Ben Mills Flat Reservoir (09899)

Water Right # 55-13839

INTEROFFICE MEMORANDUM

TO: FILE 55-13839
FROM: DANIELLE FAVREAU
SUBJECT: IN HOUSE REVIEW
DATE: OCTOBER 21, 2013

Ben Mills Flat Reservoir (09899)
Water Right # 55-13839
T. 12 s., R. 3 w., Sec. 3

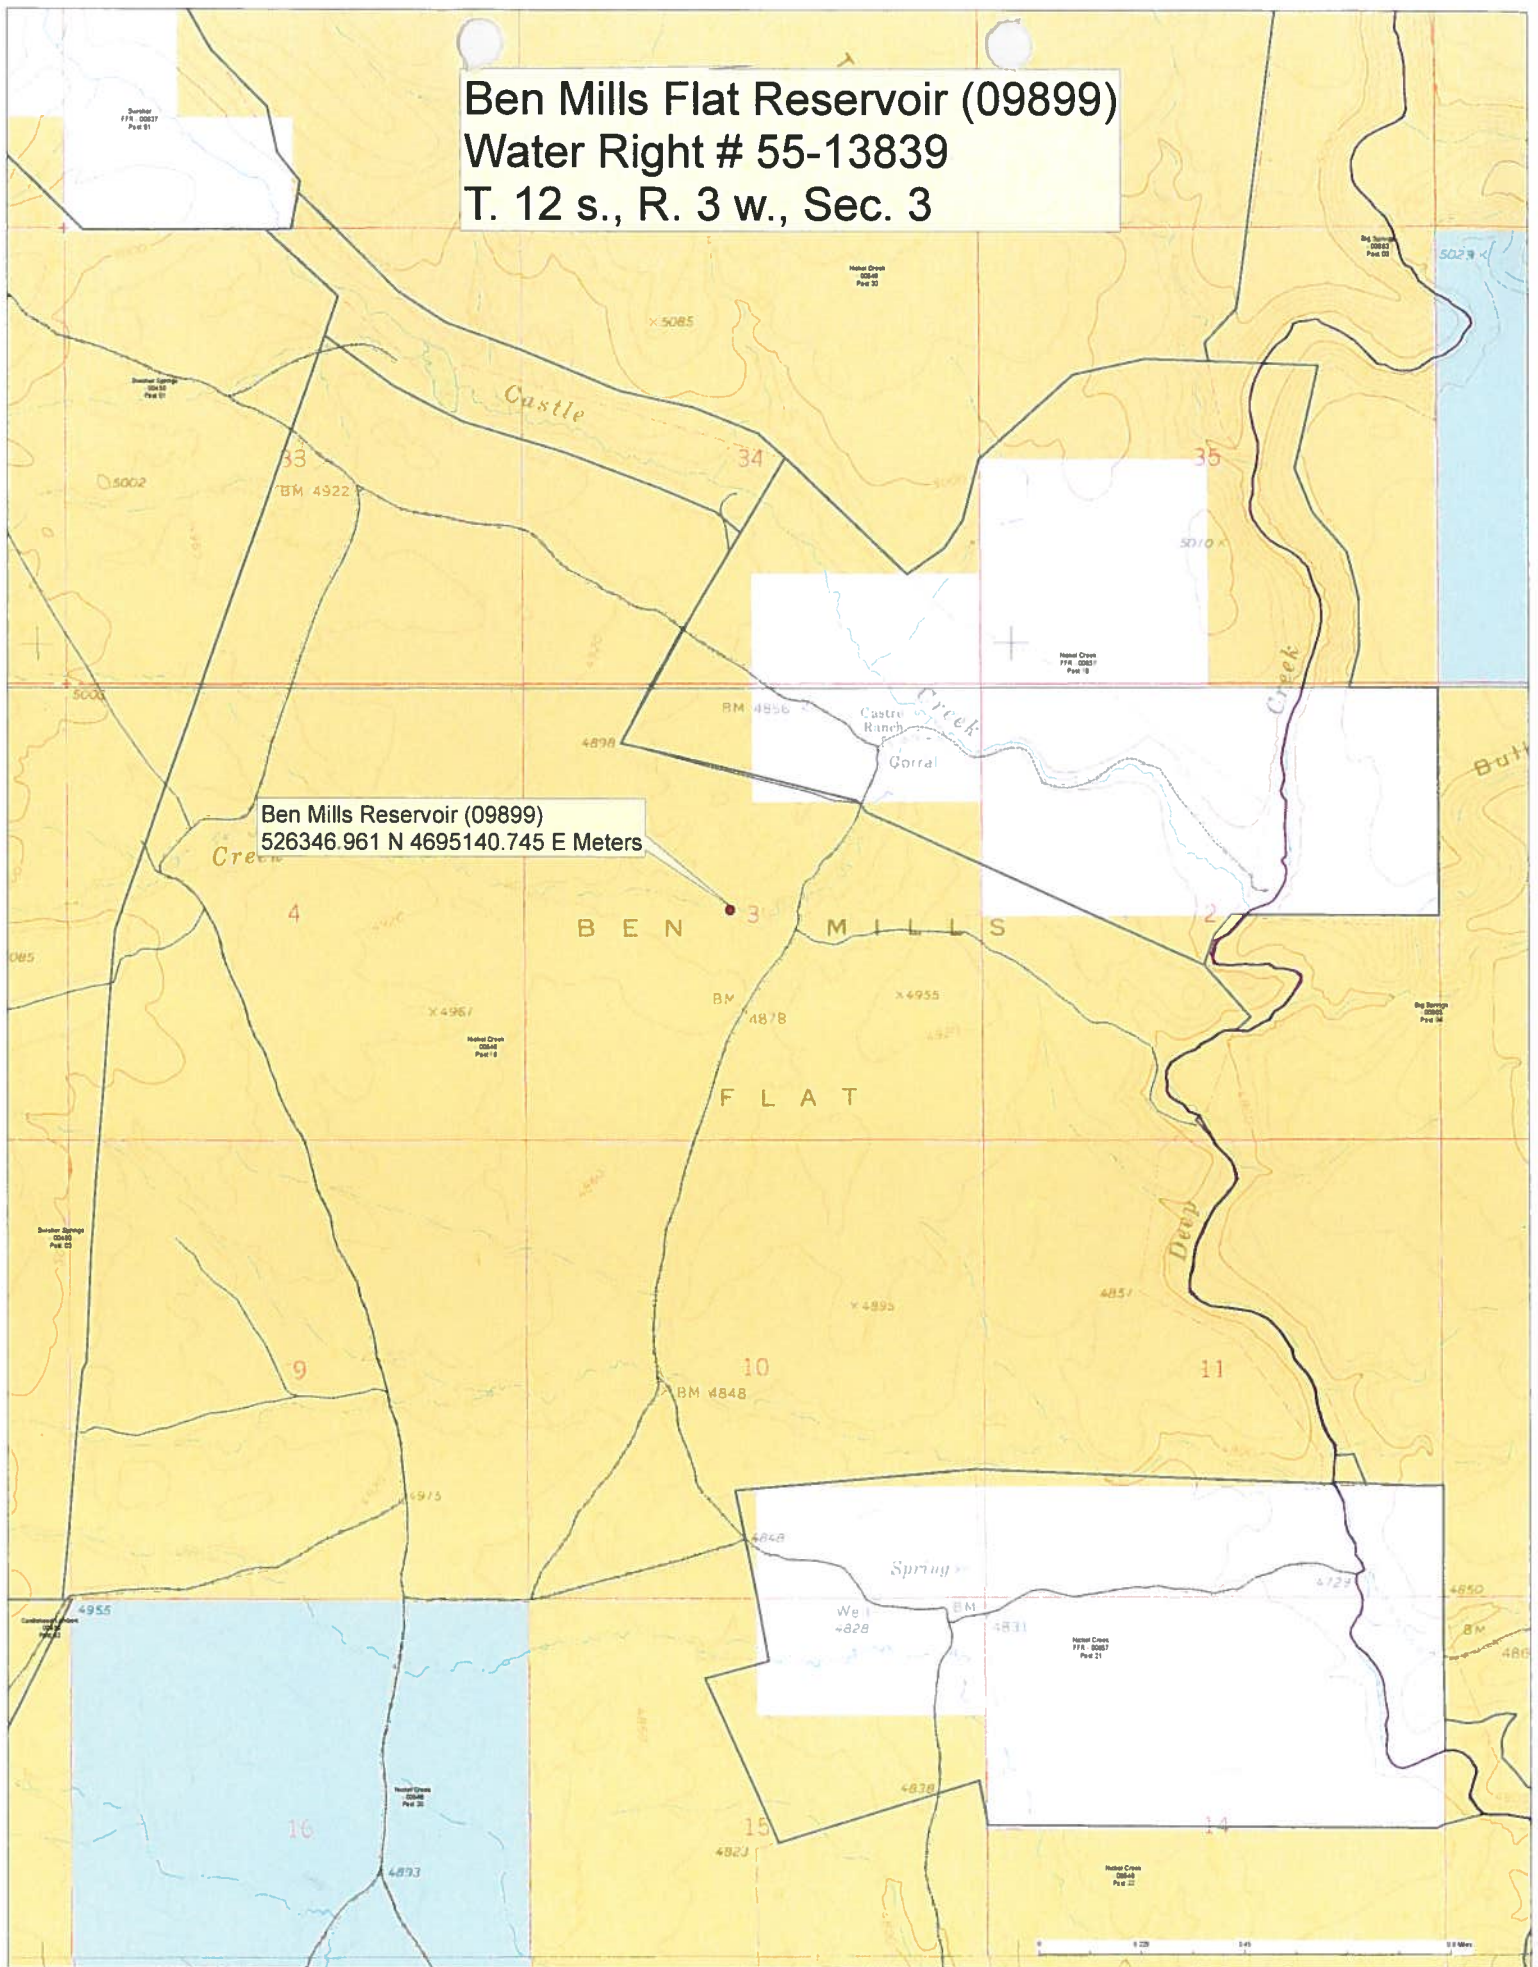
Estimated GIS area of pond = 1.2 acre. Per application: Dam height 5 ft. Per permit holder ave. pond depth = 6.5 ft.
Volume of pond calculated as follows: (6.5 ft deep)(1.2 ac surface area) = 7.8 acre feet.

Average Depth 6.5 ft.

Overlap review

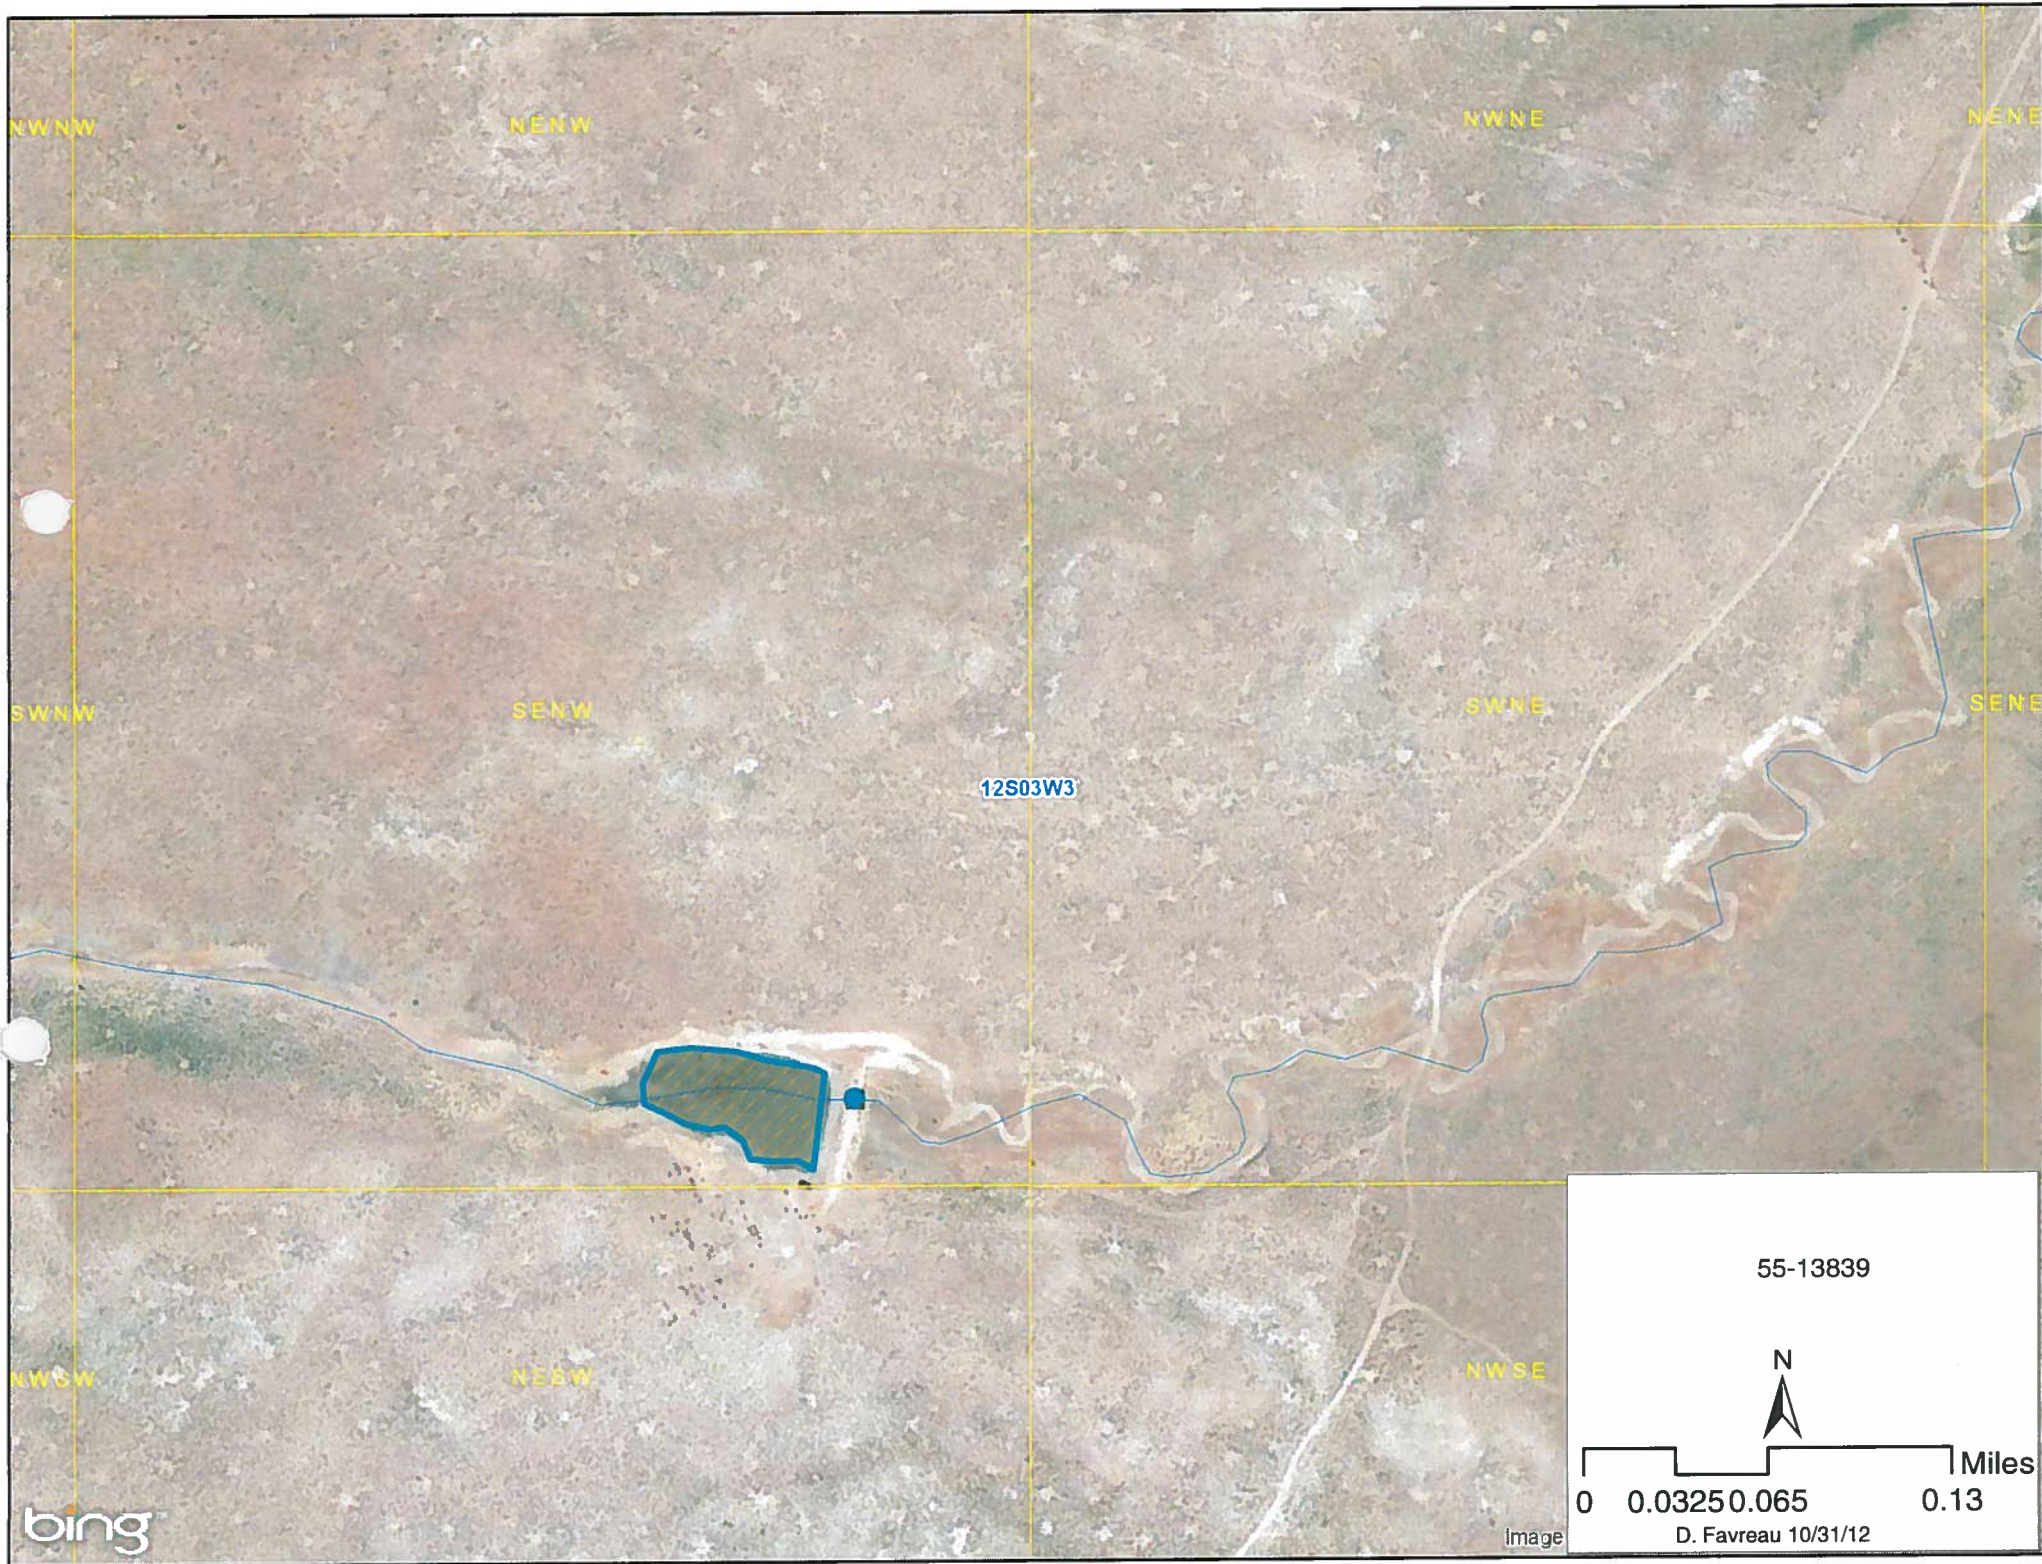
POU – No Overlap
POD – No Overlap

Missing Elements

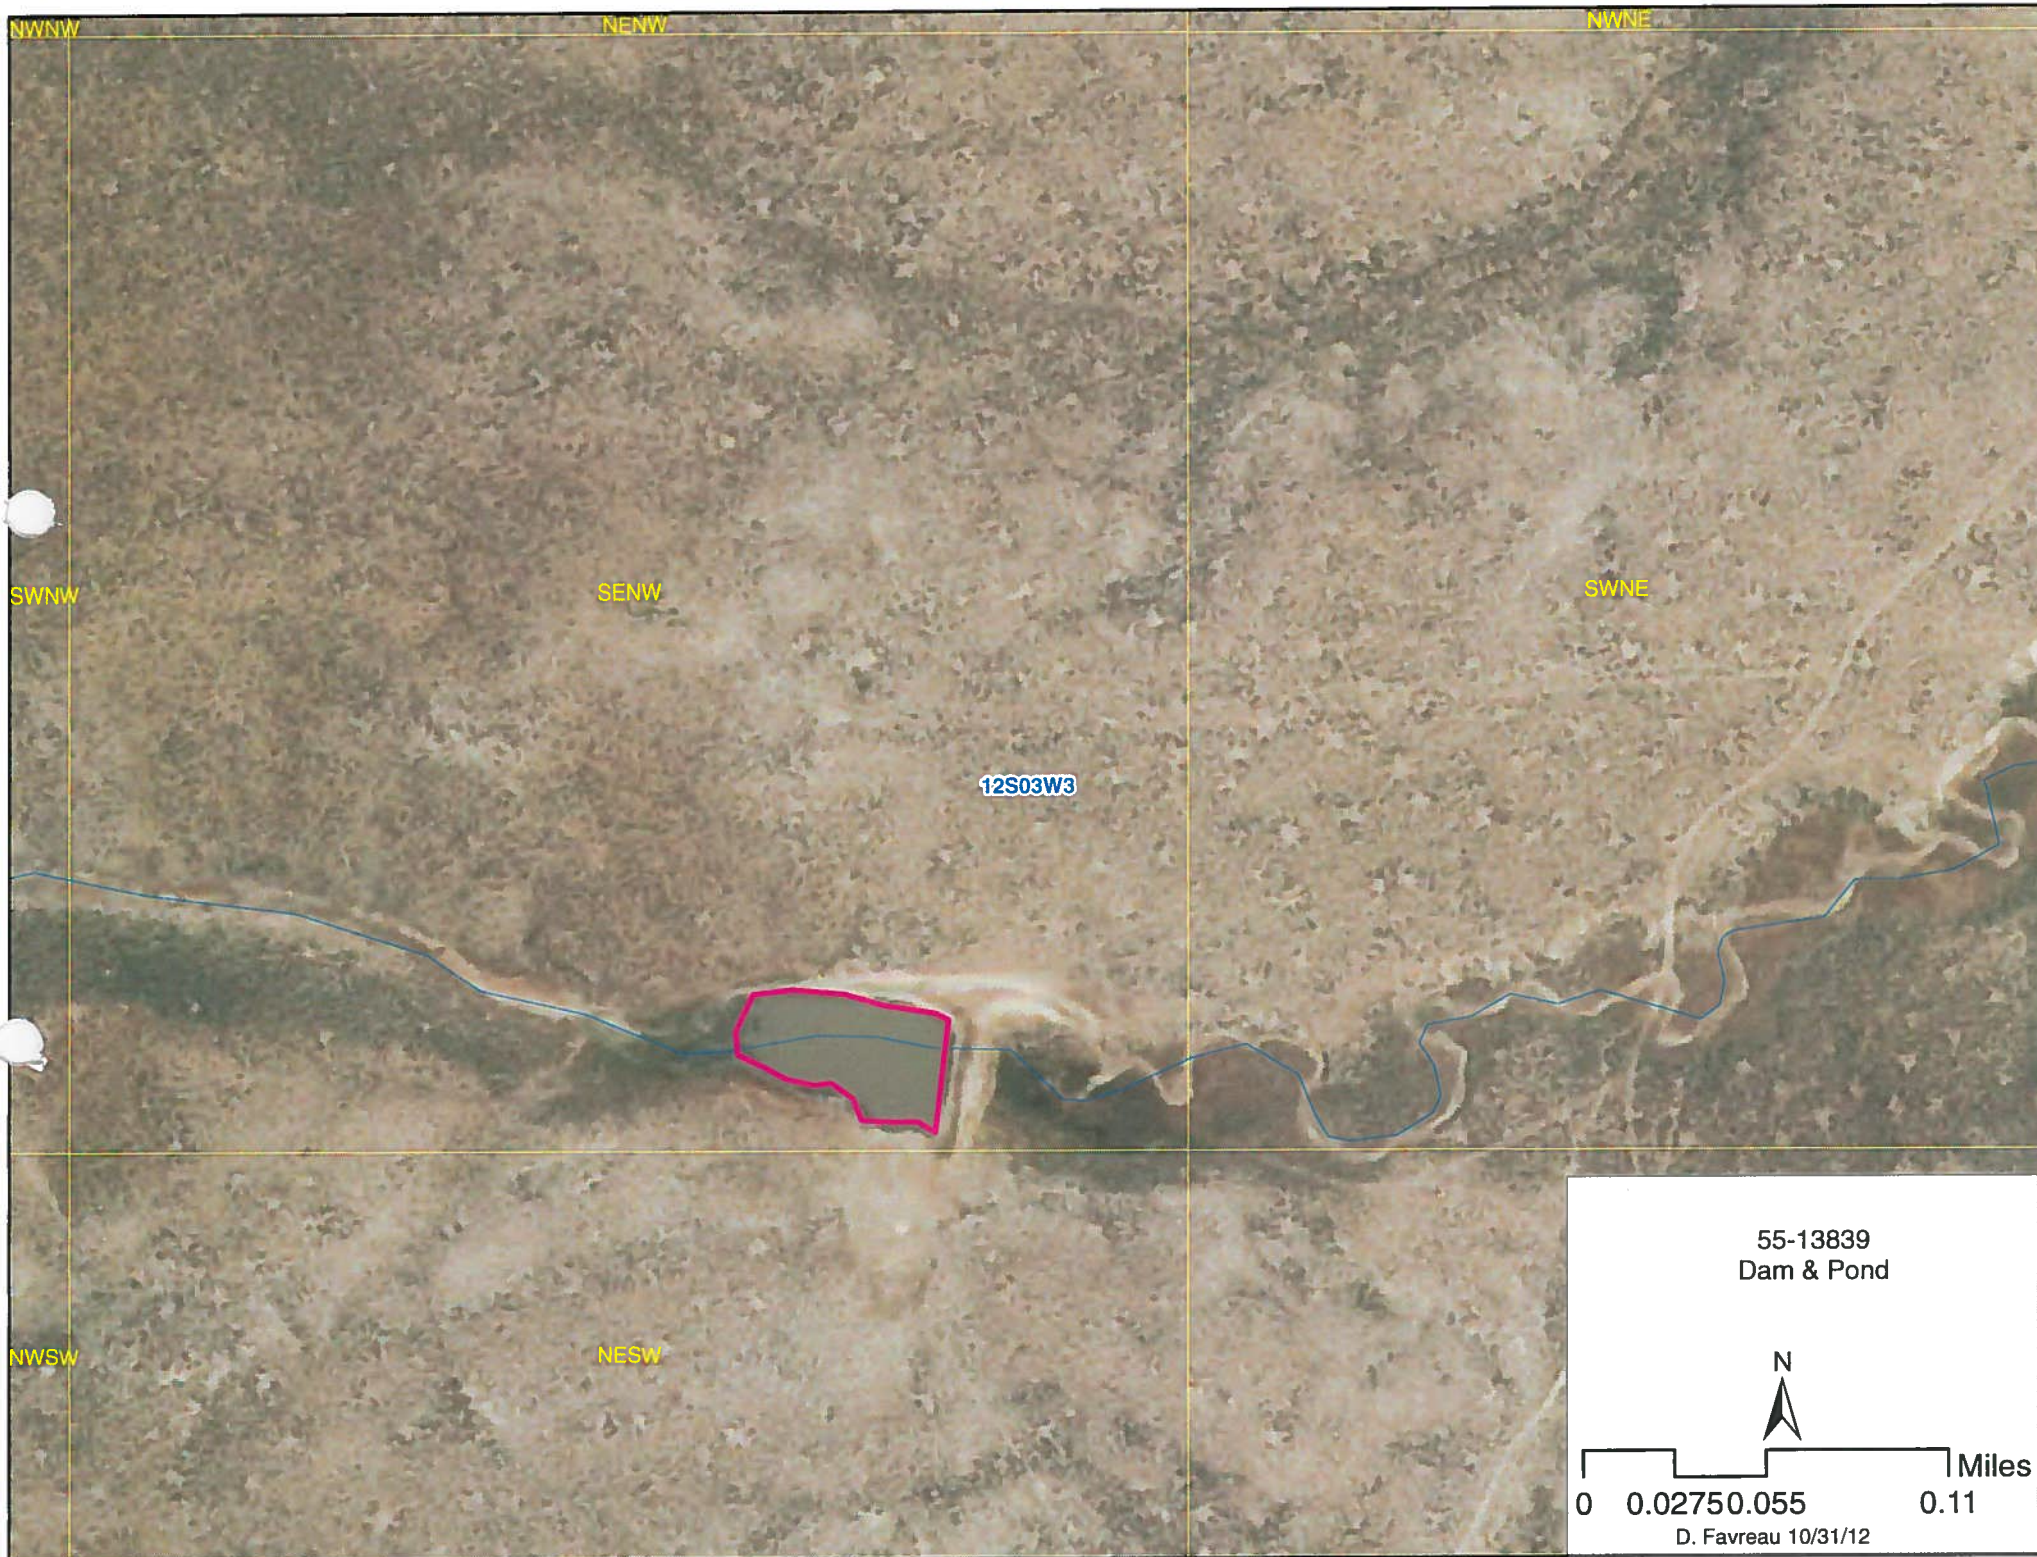
Need GPS of POD and POU.
Need Pond Depth

Per GIS Imagery, POD and POU are in SENE of Sec. 3 of T12S03W not permitted SWNE of Sec. 3 of T12S03W.

Is an Amendment Needed? YES
